22 July 2019

**SECTION 4.55(1A) MODIFICATION APPLICATION TO SSD 16_7919
85 CARABELLA STREET, KIRIBILLI**

Figure 1 Comparison of approved (red) and proposed building outline (ground level)
Source: FJMT

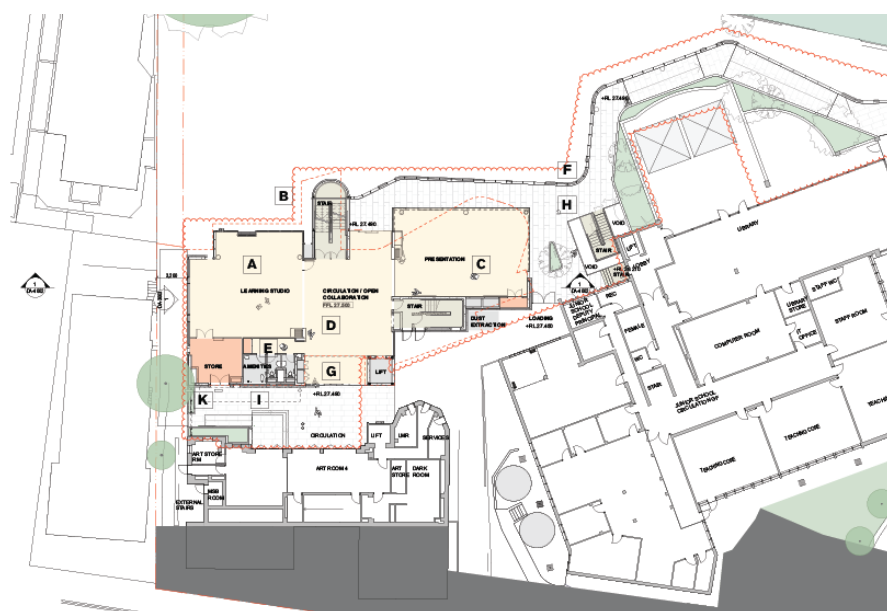
As a result of ongoing design development, the massing and scale of the Innovation Centre has been further considered to reduce the scale of the northern elevation and the northern staircase. The western wing of the new building is aligned with both the Carabella Street and Marian Centre grid. To improve the amenity and the functionality of the learning spaces, the eastern wing has now been realigned from an angled form to a straight orientation to be on the same grid. A comparison between the approved and proposed building layout (at ground level) is shown at **Figure 1**.

These changes have resulted in an overall reduction in the building mass, as well as the extent of excavation required. Whilst the RL of lower ground level 3 has changed to RL17.4m to provide additional head height to the PDHPE movement and weights studio on the floor below (lower ground level 4), the RL on lower ground level 2 has not changed. Therefore, the height from lower ground level 4 to lower ground level 2 has not changed since the SSD approval and the overall building height remains consistent with the RLs approved under Condition B4 of SSD 16_7919, as outlined in **Table 2**. Additionally, in order to resolve the revised orientation of the eastern wing, the location of the southern access stairs has been marginally revised resulting in a minor change to the structures at roof level. Finally, whilst the western plant enclosure has been marginally reduced, additional low-height plant has been added to the south-eastern edge of the roof terrace to accommodate a kitchen exhaust duct and make-up air duct. An assessment of view impacts is provided at **Section 3.3.2**.

Figure 4 Photomontage of development, as proposed to be modified
Source: FJMT

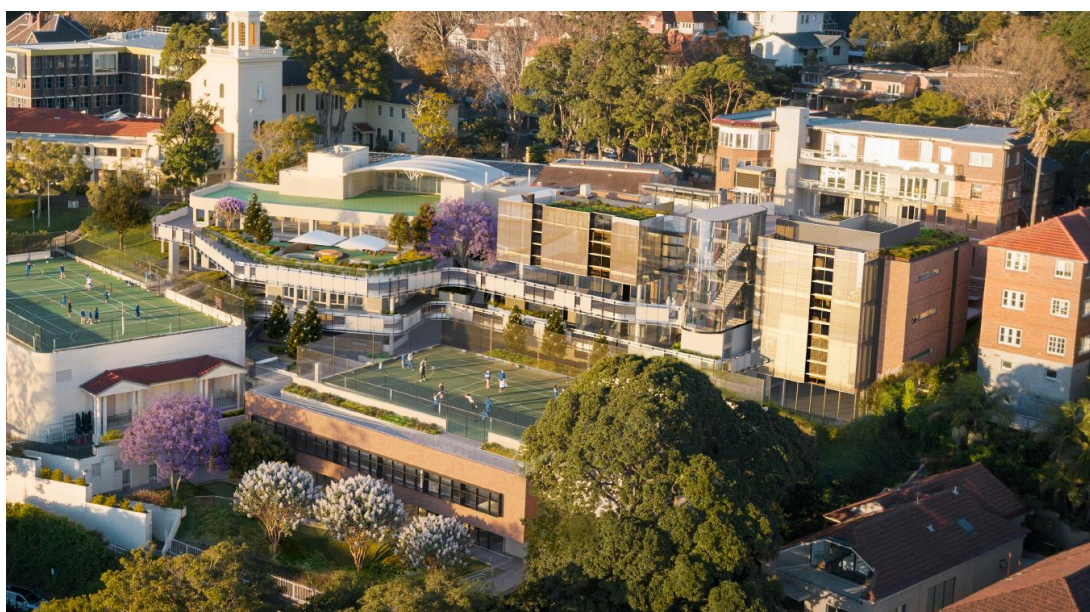
As noted above, the massing and scale of the building has been refined during design development. The northern elevation and the northern staircase have been reduced and the building's eastern wing has been realigned to a straight orientation so that it is on the same grid as the western part of the building.

Notwithstanding, the proposed building envelope is generally consistent with the approved development and remains consistent with the height and setbacks approved under the SSD application. However, in order to resolve the revised orientation of the eastern wing, the location of the southern access stair has been marginally revised resulting in a minor change to the structures at roof level.

Consistent with the approved building, the modified development (including changes to the windows on the building's western façade) carefully considers privacy from the adjacent residential buildings. Views to and from all windows in close proximity to the boundary are either high-level, screened or use opaque glazing.

Figure 3 and **Figure 4** provide a comparison between the approved building and the development, as proposed to be modified.

Table 4 Northern Visual Impact (approved building outlined in red)

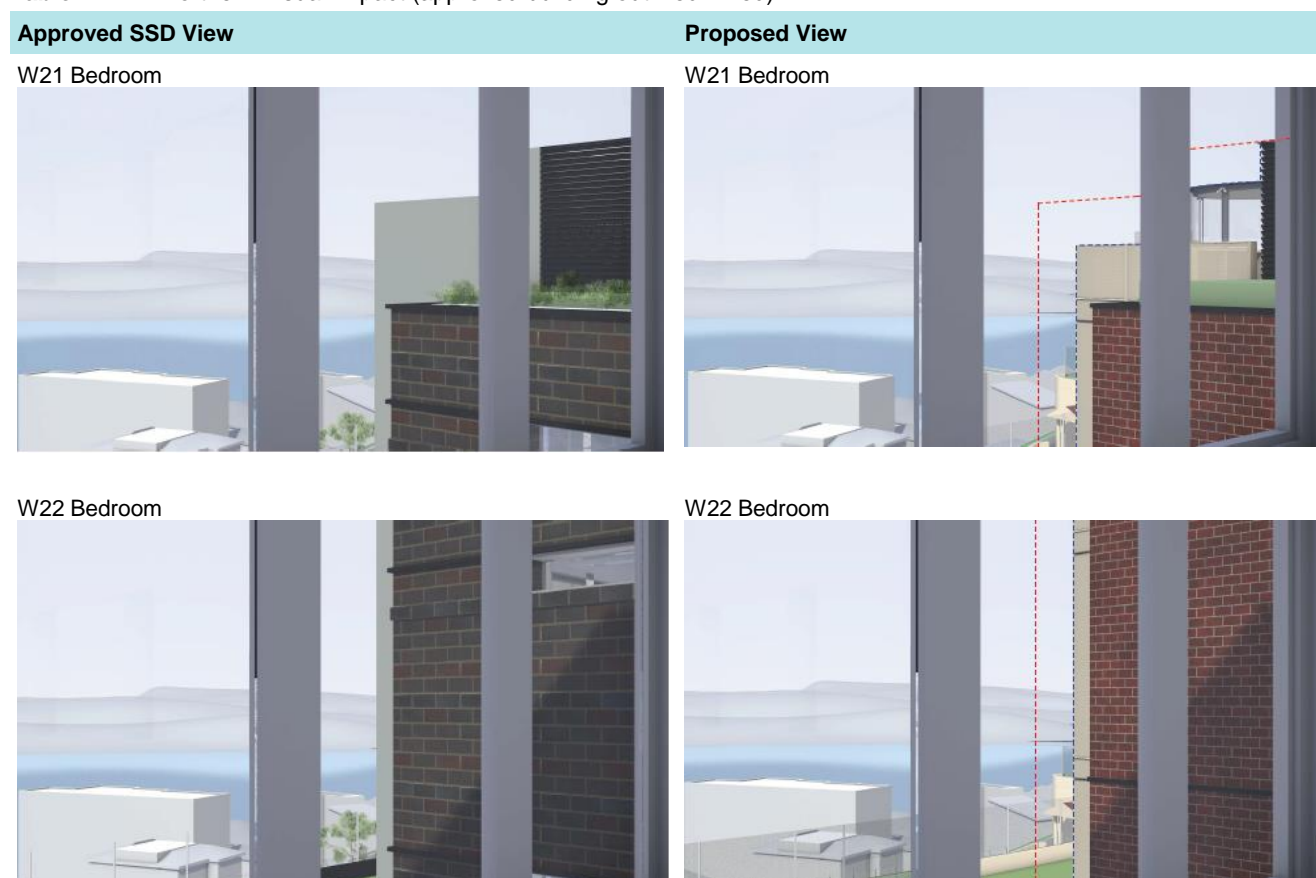
Table 4 compares the views from W21 and W22 (bedrooms), taken from a worst-case viewpoint looking obliquely across the school site. The comparison shows that the proposed amendments to the building mass will improve view impacts from the northern apartments in 111 Carabella Street when compared to the approved development.
